**JOHN MAISSAN
(JM)**

1 **TOPIC: Section 2 Overview of the Project**

Outage statistics – AEY Line 6L11

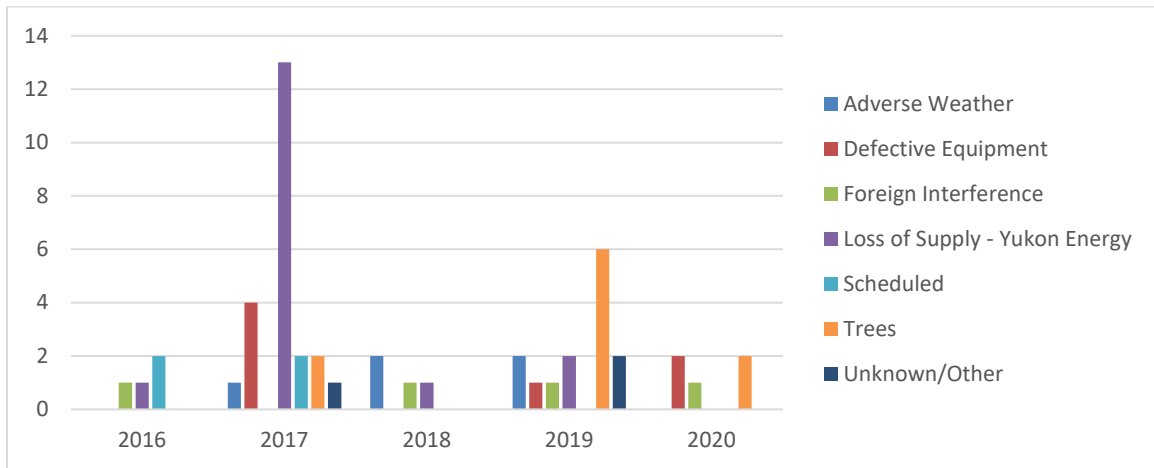
14 a) Please provide the reliability criteria for this portion of ATCO power line and
15 compare this to similar criteria for YEC’s 138 kV and 69 kV power lines.

25 The question is not specific with respect to which YEC line to compare; YEC does not
26 have consolidated data so the following graphs are from sample lines – i.e., for 138 kV –
27 L171 – Aishihik to Takhini; for 69 kV – L176/7 – Mayo to Dawson

Appendix 1 - Expanded Figure 2-1

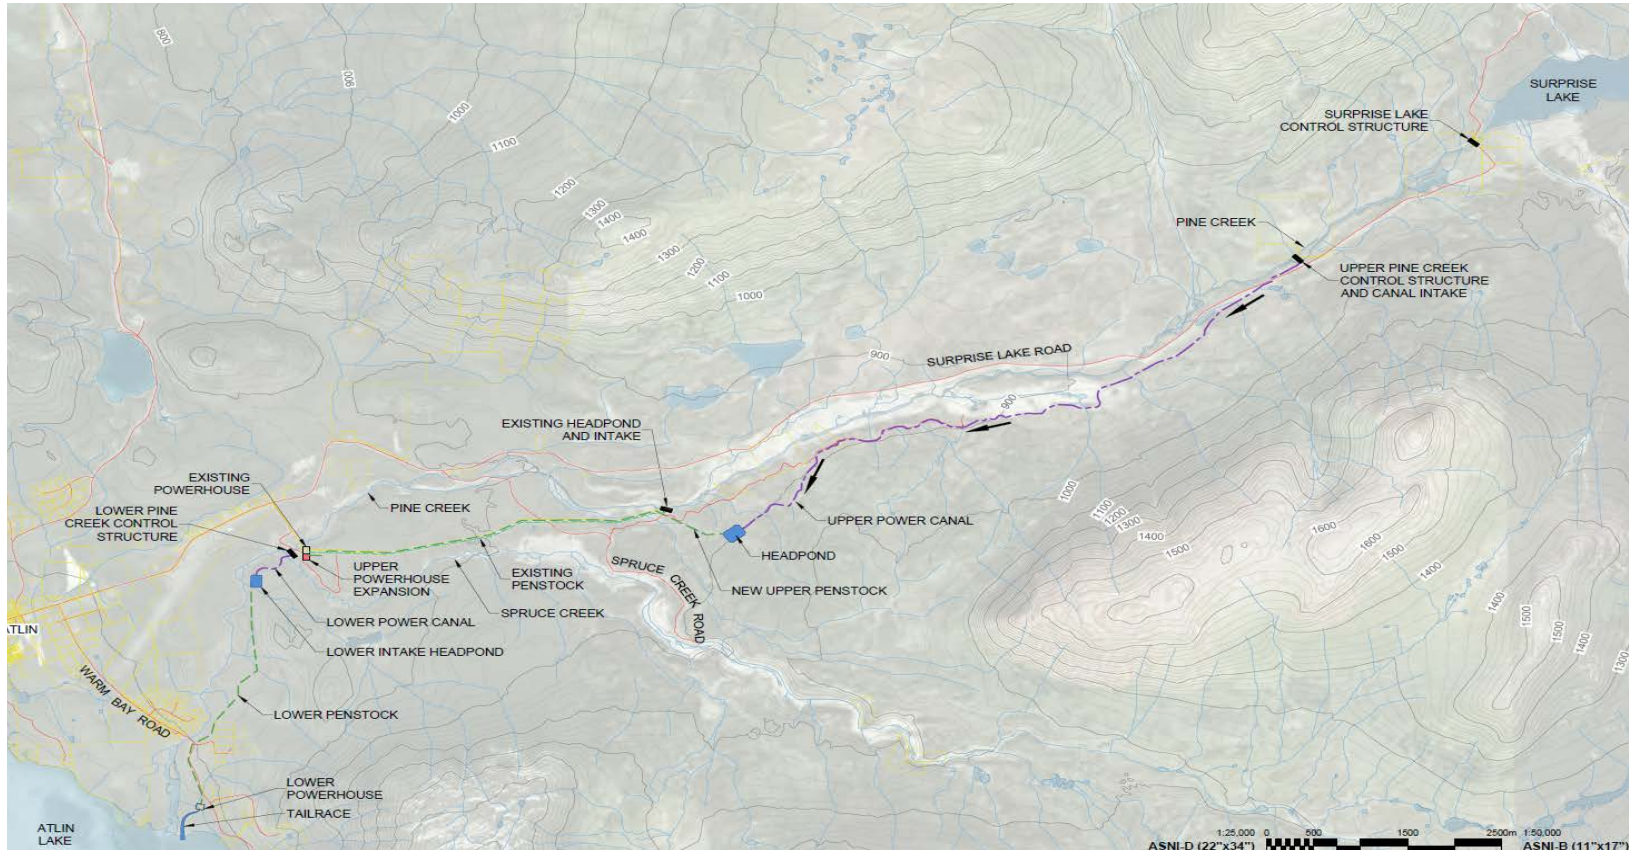
9 a) Please provide a digital higher resolution version of Figure 2-1 so that all the project
10 components can be clearly seen.

19 Appendix 1 provides an expanded Figure 2-1 so that all project components can be clearly
20 seen.

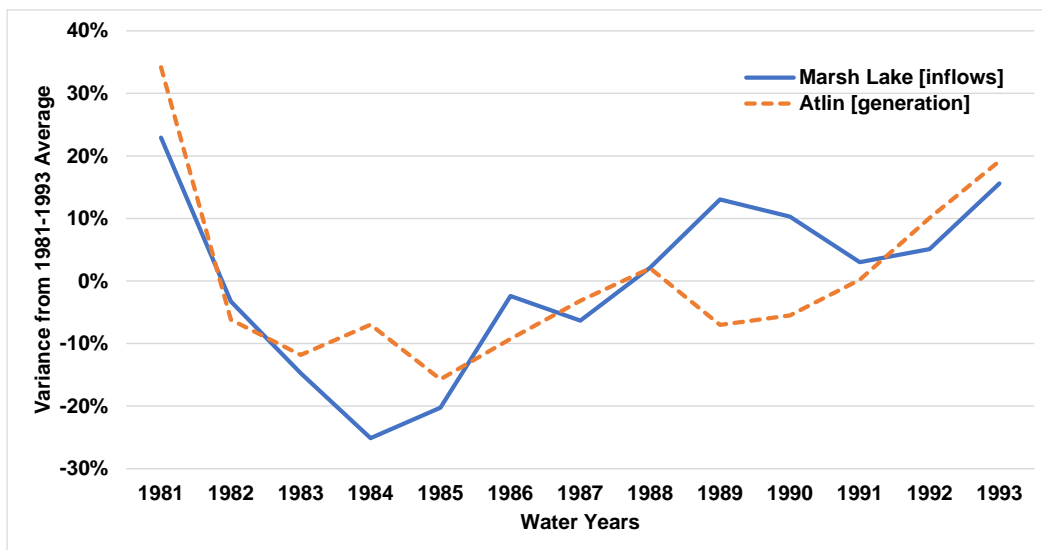
16 a) Has YEC calculated the correlations of the Atlin Surprise Lake water years with
17 each of the following and if so, please provide the results, and if not please explain
18 why not.

8 YEC has not calculated the correlations asked about in this question. Available information
9 is reviewed below. The thermal energy displacement calculations utilize 38 water years of
10 simulated weekly YIS hydro generation that include the YIS as a whole, and provide
11 estimates that are as accurate as possible based on the current information.

17 There are, however, similarities between basins for Whitehorse Hydro storage facilities
18 and Atlin. The figure below illustrates correlation of Marsh Lake inflows for 1981-1993
19 water years to simulated Atlin generation for the same water years.¹

Figure 15: Monthly Renewable Supply vs Demand (2030)

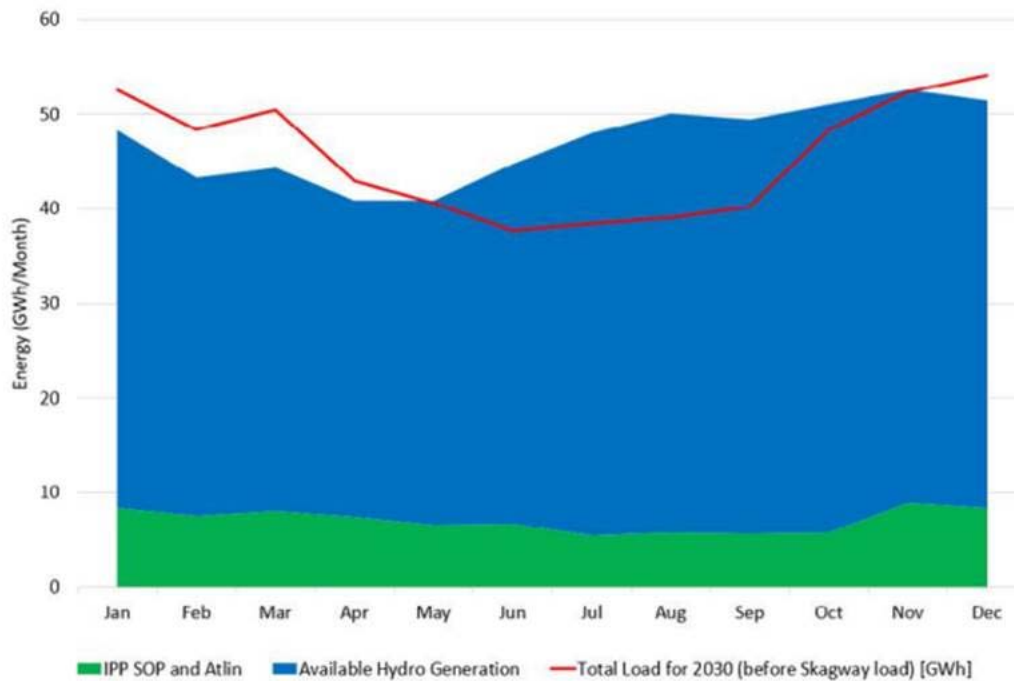
24 d) Has YEC considered marketing secondary sales to other customers to increase
25 secondary sales volumes and reduce greenhouse gas (GHG) emissions in line
26 with the Yukon government’s Our Clean Future climate change strategy?

32 Yukon Energy does not have any surplus renewable energy in the winter months
33 (November through April). Surplus renewable energy is typically available June through
34 October. The figure below illustrates the expected renewable surplus on a monthly basis
35 (Figure 15 from the 10-year Renewable Electricity Plan – see YUB-YEC-1-32, Attachment
36 1).
